Amendments to the Drawings

SB MIZIKOVSKY 25

FIG. 3B

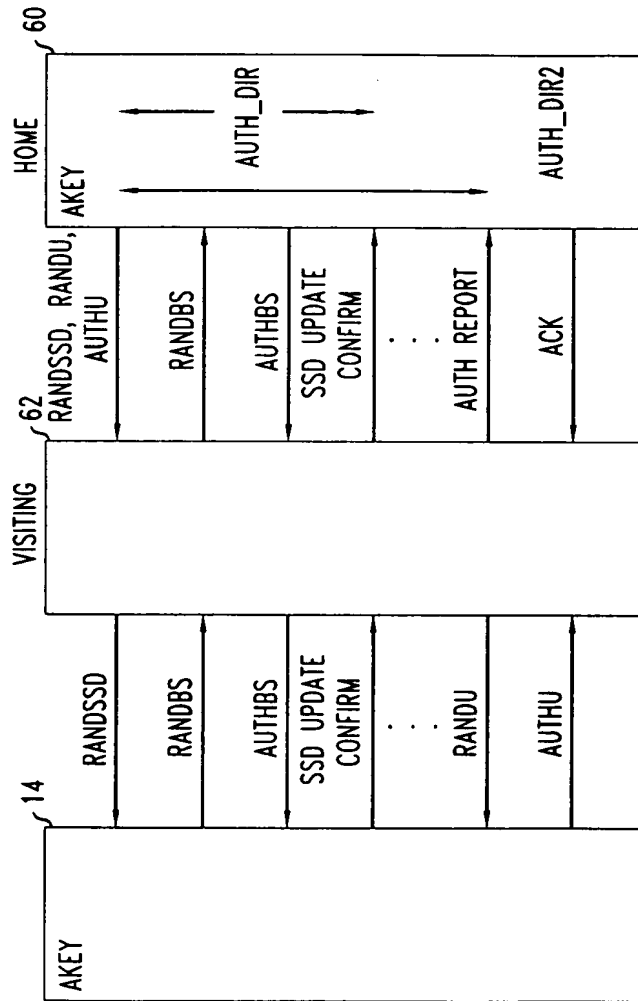
New formal drawings are being submitted herewith for the application. Amendments to the drawings were made to put the drawings in conformance with the written description. In FIG. 3B, AUTHREQ was deleted, and in FIG. 4, SSD_KEY was made the output of function (F0) 67 and SSD_NEW the output of function (f1) 68 on the unit side.
